Addendum #1

Carlsborg/Van-Lan Water System Blending, Phase 1 Public Utility District No. 1 of Clallam County

Date Published: October 30, 2023
Date of Addendum #1: October 27, 2023
Date of Bid Opening: November 2, 2023

CEMENT CONCRETE DRIVEWAY ENTRANCE TYPES 1, 2, 3, & 4 STANDARD PLAN F-80.10-04

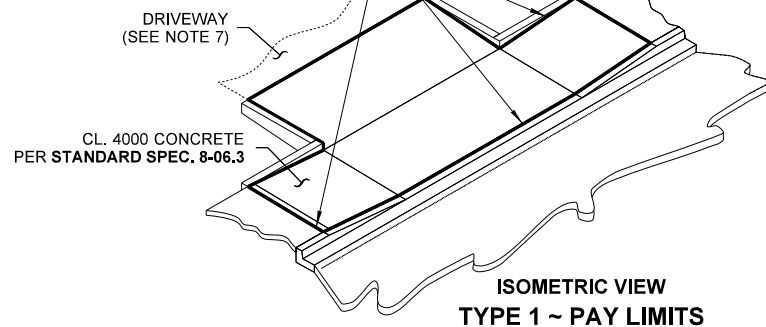
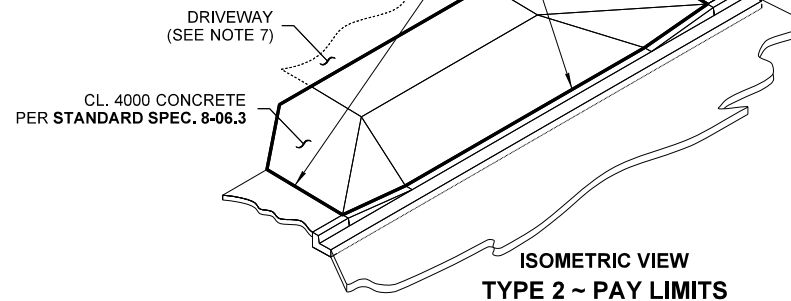
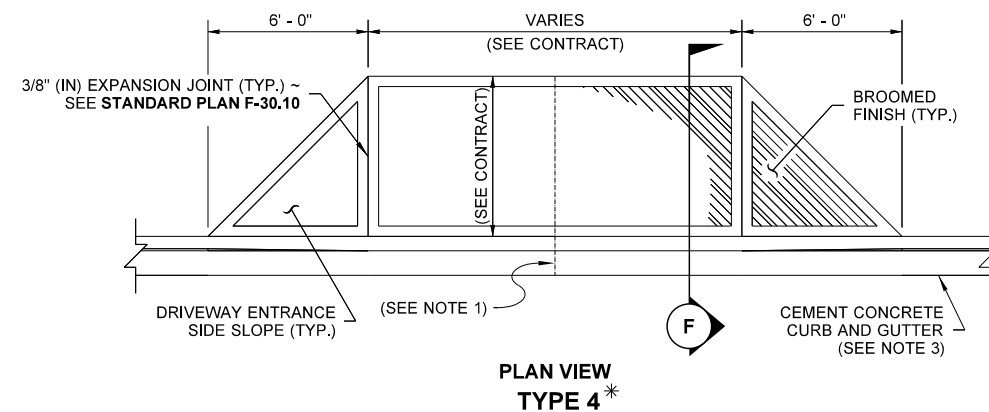
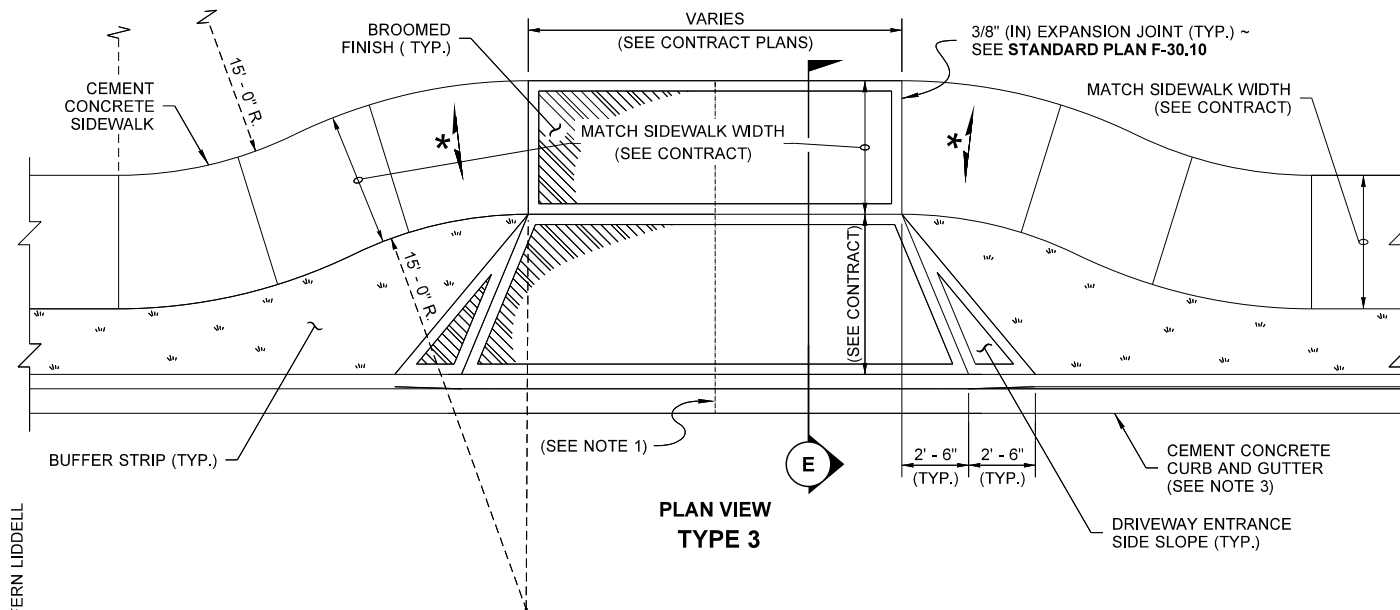
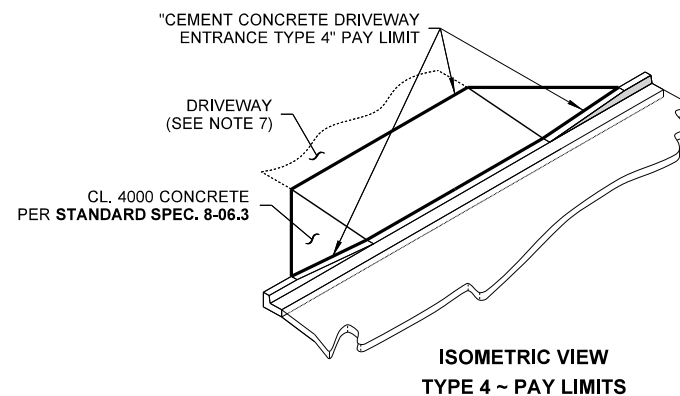
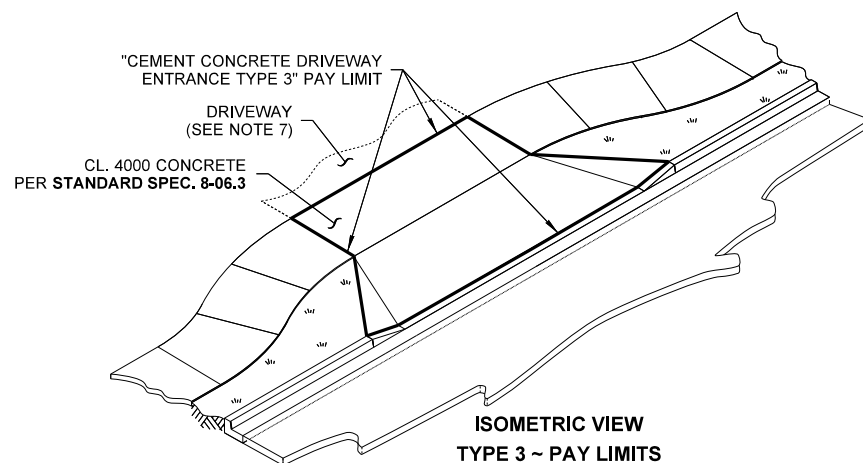
Installation of the driveway shall be in accordance with WSDOT Standard Plan Cement Concrete Driveway Entrance, F-180.10-4, Type 4 (attached). New driveway entrance shape, alignment and slope shall match existing. Place and compact a minimum of 4-inches of CSTC material prior to concrete placement. Removal, haul, and disposal of material to accommodate the CSTC material shall be included in this pay item.

Drawing: **C-4**

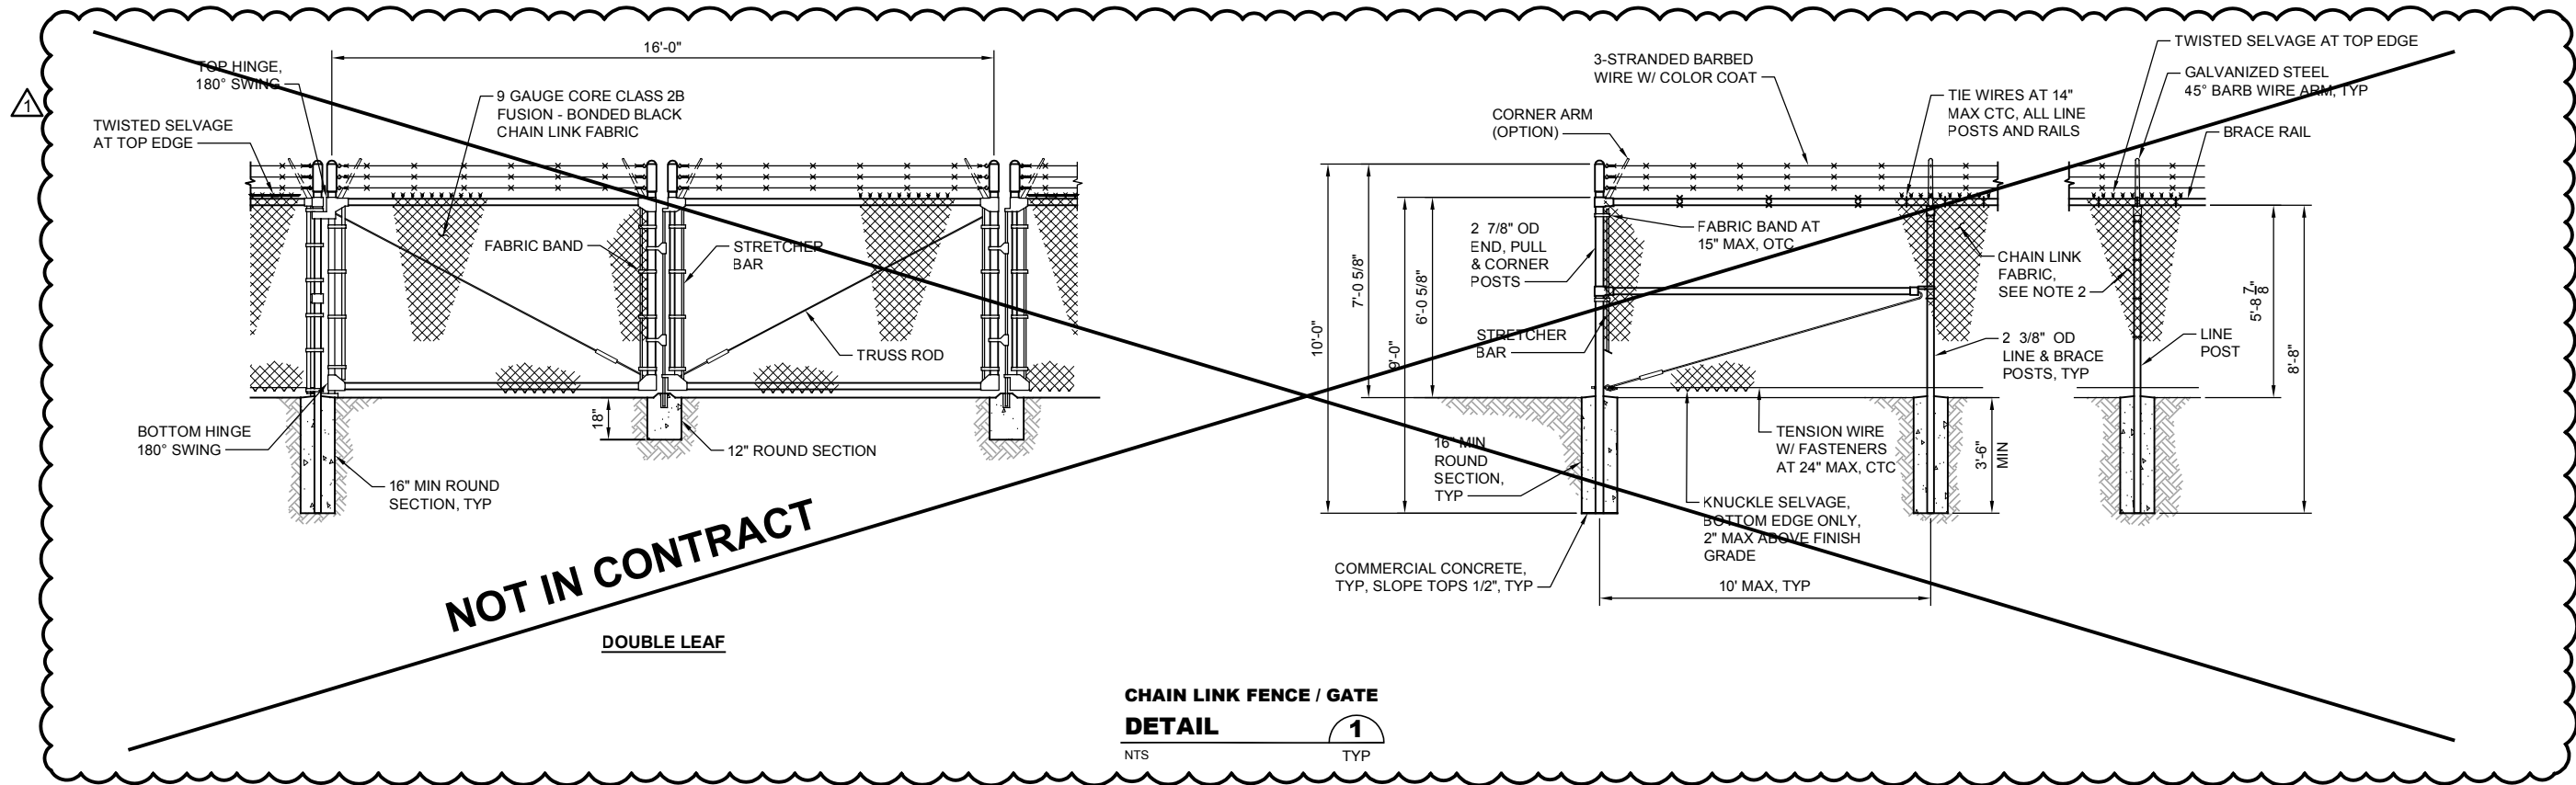
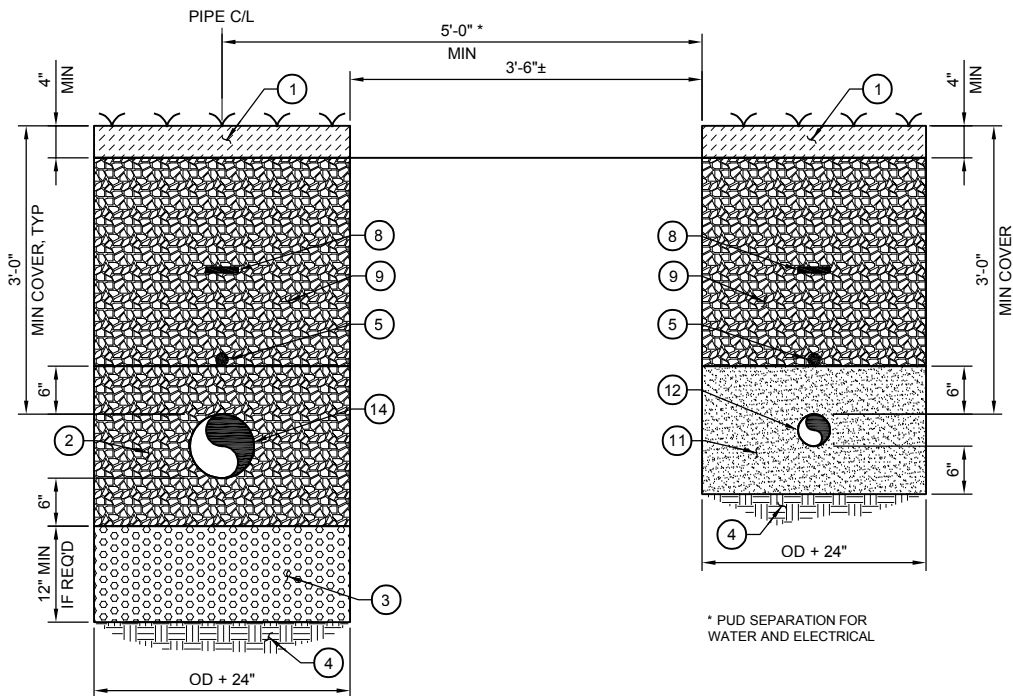
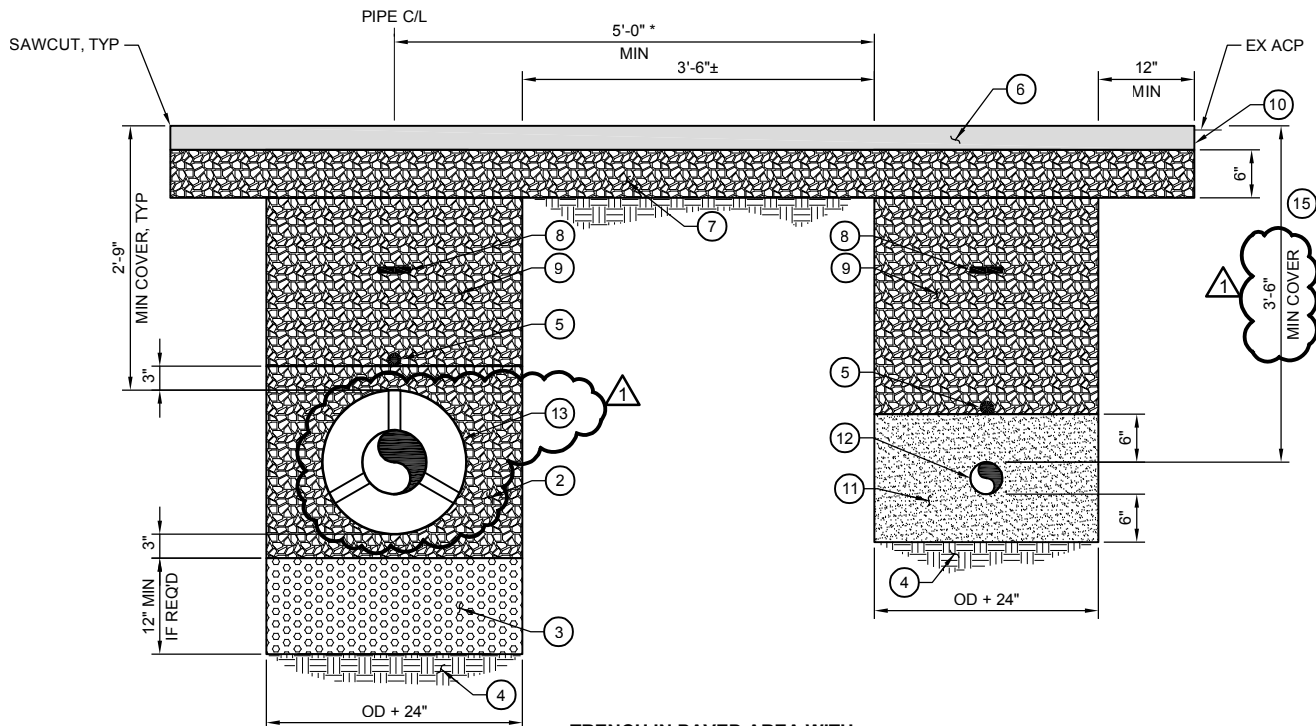
1. See modifications to C-4 attached.
2. See modifications to C-101 attached.
3. See modifications to EC-114 attached.
4. See modifications to C-114 attached.
